Proposed Revisions to a Standard Plans Index

Index Number: 102-604 Sheet Number (s): 1 and 2 of 2

Index Title: Two-Lane, Two-way, Intersection Work

SHEET 1 of 2

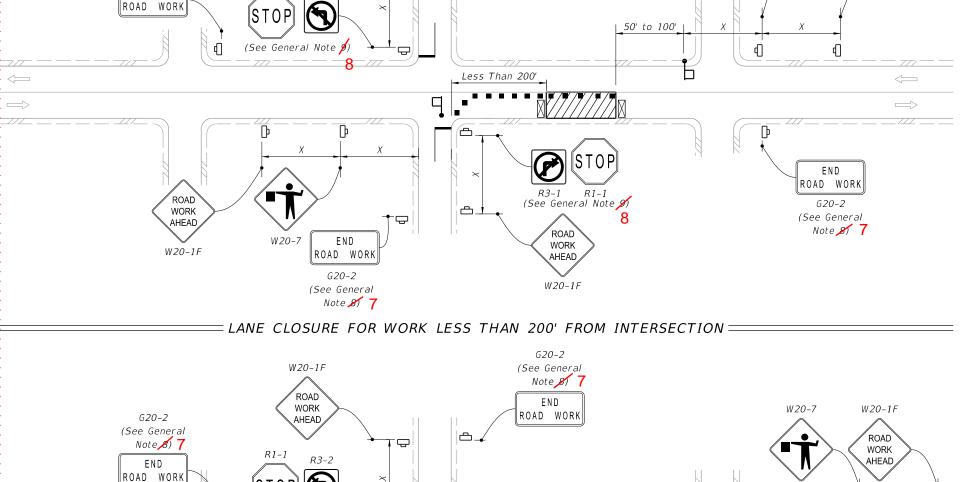
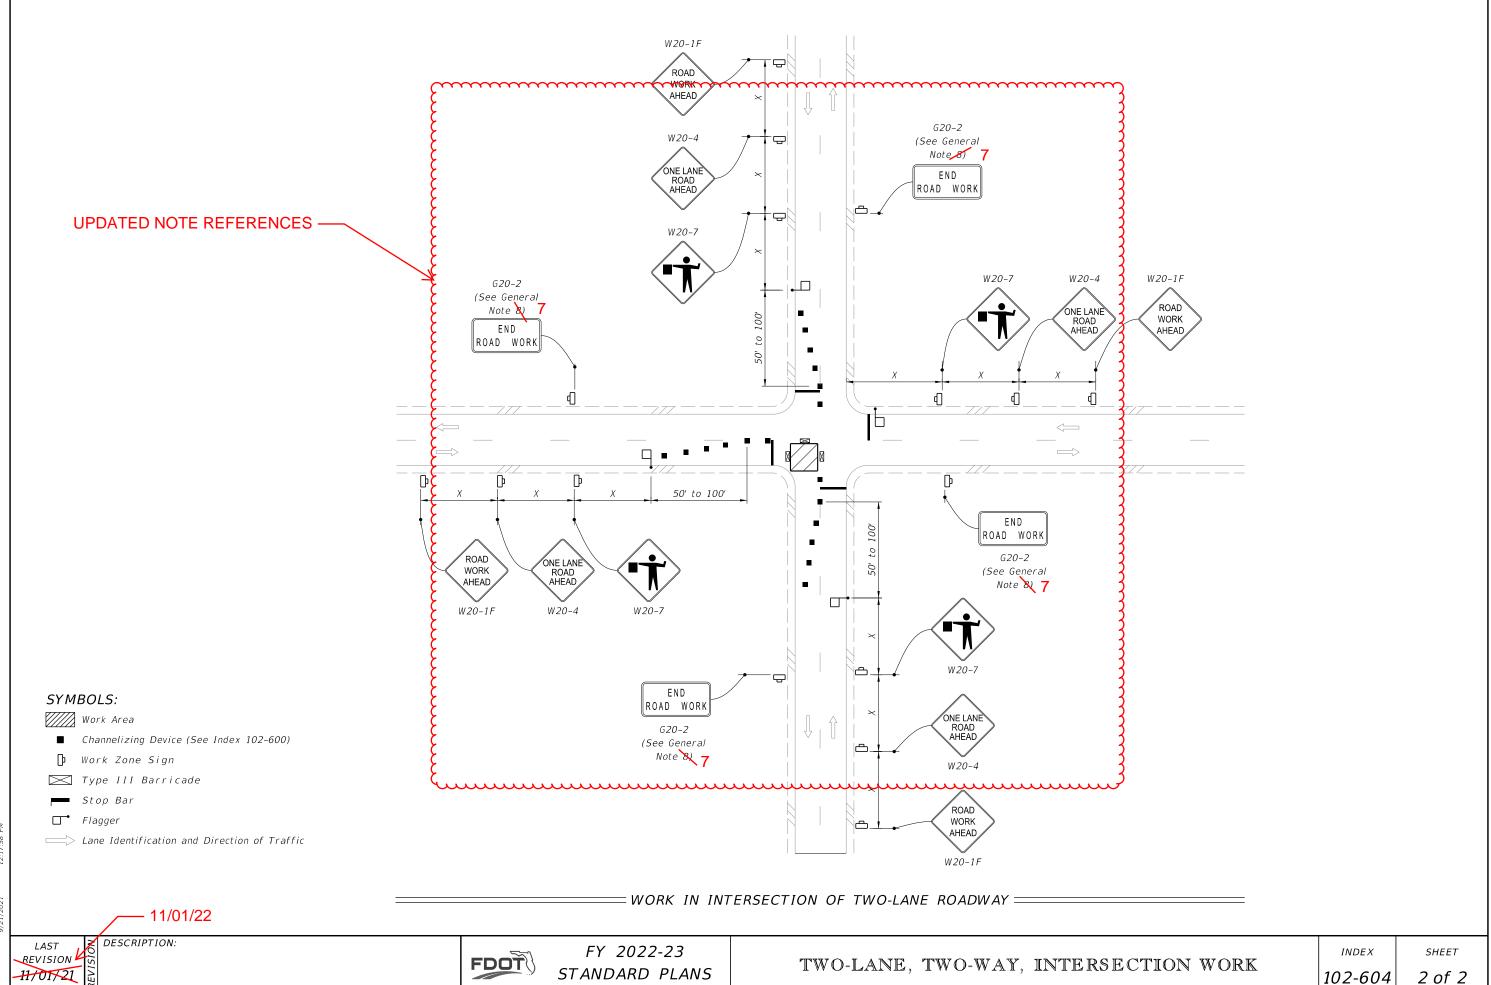
Sheet 1: Deleted Note 6 "District Traffic Operations Engineer must approve temporary signal phasing modifications prior to beginning or work" and added to Specification 102-9; Updated the Note callout references in the details.

UPDATED NOTE REFERENCES

The note was moved to the Specifications to provide guidance to the contractor in one area for all temporary signal timing.

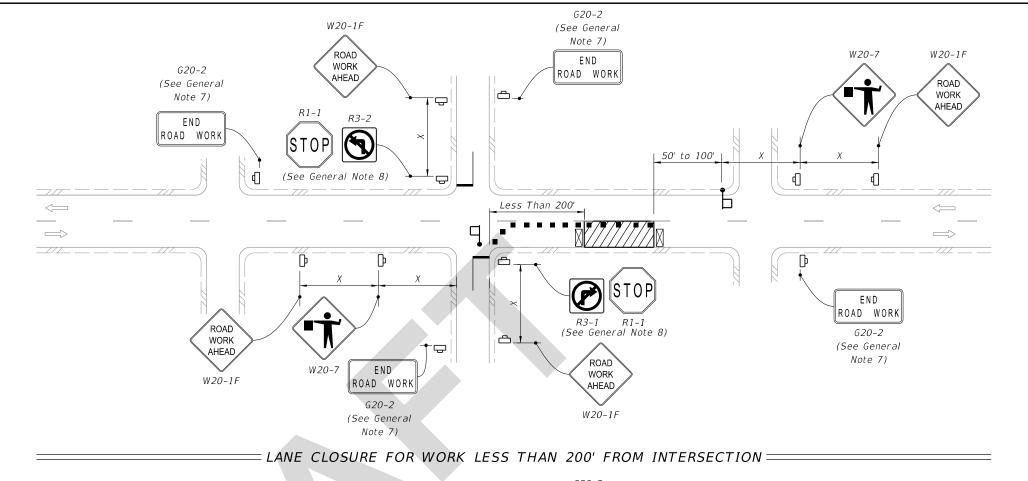
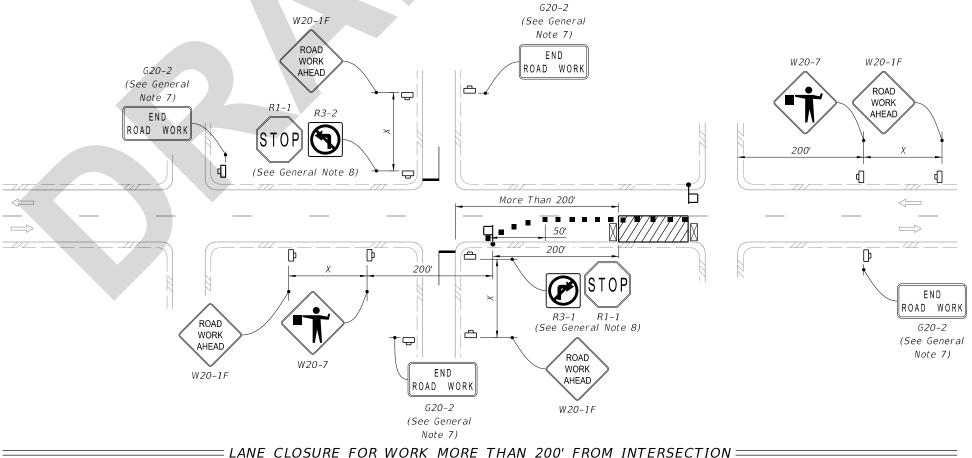
Sheet 2: Updated the Note callout references in the details.
